**Request for a planning proposal for  
42-58 Old South Head Road, Vaucluse – Application 2**

## **Attachment 1: Request for a planning proposal for 42-58 Old South Head Road, Vacluse – Application 2**

### **Additional information required following initial review**

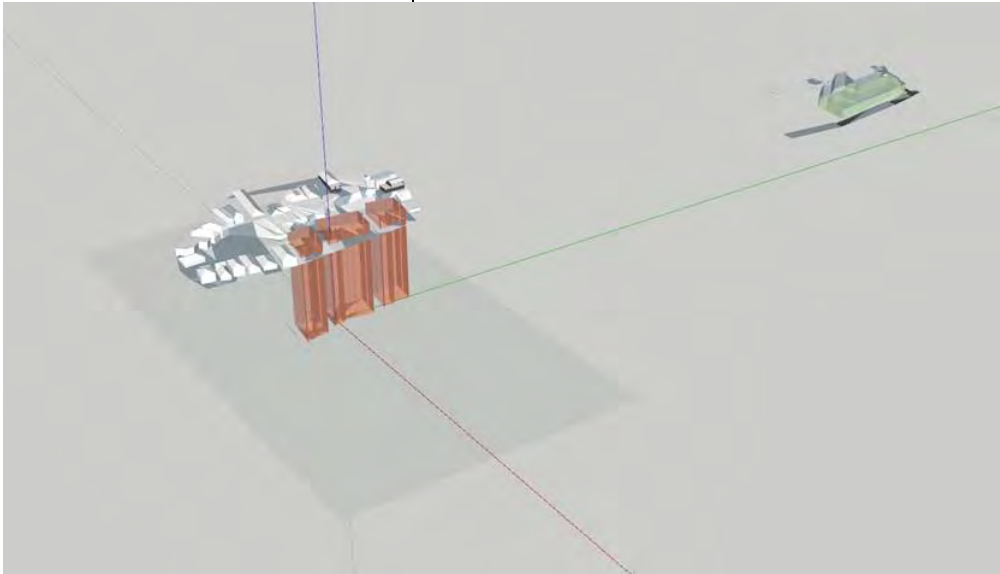
The 3D Digital Model provided has not been provided in the format required by Council. The model failed to import correctly into SketchUp. Additionally, a number of texture files are required. Refer to Checklist 2 for additional information.

Pre-lodgement Advice Matters	Information Provided and Comment	Matter Addressed
	<p>Owners' consent has been provided for:</p> <ul style="list-style-type: none"> <li>• 46 Old South Head Road</li> <li>• 48 Old South Head Road</li> <li>• 50 Old South Head Road</li> <li>• 58 Old South Head Road</li> </ul> <p>Owners' consent has <b>not</b> been provided for:</p> <ul style="list-style-type: none"> <li>• 42 Old South Head Road</li> <li>• 44 Old South Head Road</li> <li>• 52 Old South Head Road</li> <li>• 54 Old South Head Road</li> </ul>	
Consultation with surrounding property owners	No information provided. We strongly encourage early discussions with neighbours to minimise potential conflicts.	✘
Disclosure statement (political gifts and donations)	Provided.	✓
3D digital model	<p>Not adequately addressed. The 3D Digital Model provided has not been provided in the format required by Council. The model failed to import into SketchUp correctly, refer to image below.</p>  <p>Additionally, the following texture files are required.</p>	✘
